City Hall Exterior Design

Alternative Proposal:

Key Plan

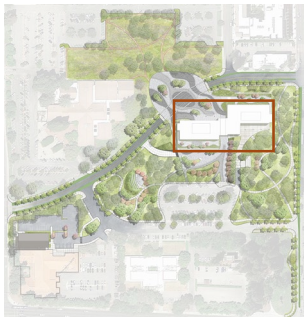
Alternative Proposal:

- Reduce 1st Floor area by 1,187 SF
- Reduces area of parking level to by 2,810 SF
- Reduces parking from 98 stalls to 89 stalls
